South Texas Project Electric Generating Station P.O. Box 289 Wadsworth, Texas 77483

January 20, 2010
U7-C-STP-NRC-100026

South Texas Project
Units 3 and 4
Docket Nos. 52-001
Response to Request for Additional Information

This letter provides responses to Request for Additional Information (RAI) Letter Numbers 3 and 4 related to the application to amend the ABWR DCD Part 2, Tier 2, Sections 5.2 and 7.7 provided in Attachment 1 to the referenced letter. This submittal completes the responses to these RAI letters.

FIGURE 6.2-39 ATMOSPHERIC CONTROL SYSTEM P&ID (Sheet 2 of 3)
ABWR DCD/Tier 2 Rev.5

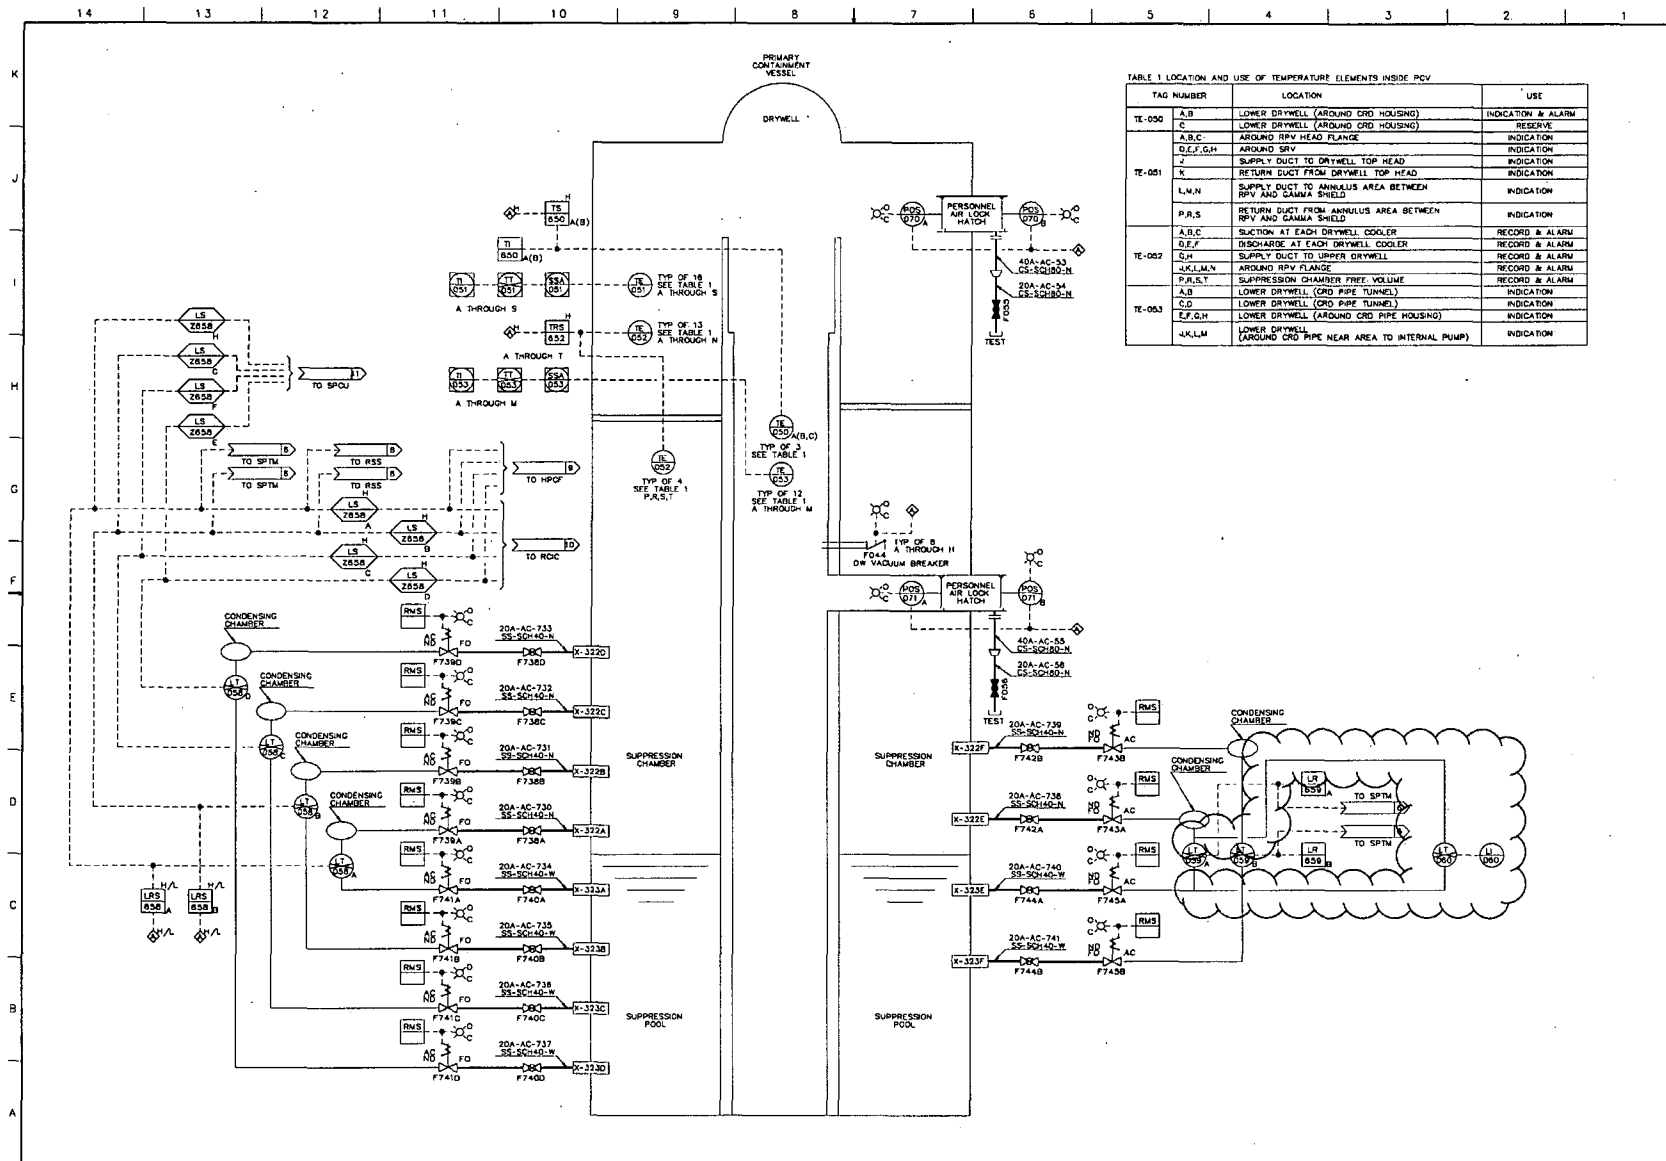
The staff request the applicant to clarify how and where the connection is made from which the AFI system gets its instrumentation signals and to demonstrate that the instrumentation included in the new AFI system does not create any potential for inadvertent actuation or creates challenges to current safety systems.

The instrumentation connections for the AFI system are shown in the marked-up drawings for FSAR Figure 5.1-3, Sheet 5 provided in the original amendment submittal and in updated Figure 6.2-39, Sheets 2 and 3, attached to this RAI, which supersedes the Figure 6.2-39 markups provided in the original submittal. There are no automated control systems or functions for the AFI system, because it is a manually operated system. The instrumentation for the AFI system only includes indicators that are for operator information. In addition, the water level and pressure instrumentation in the AFI pump room uses separate transmitters and power supply from existing instrumentation. Consequently, the AFI system does not create any potential for inadvertent actuation or challenges to current safety systems.

FSAR Figure 6.2-39, Sheets 2 and 3 are changed as a result of this response.
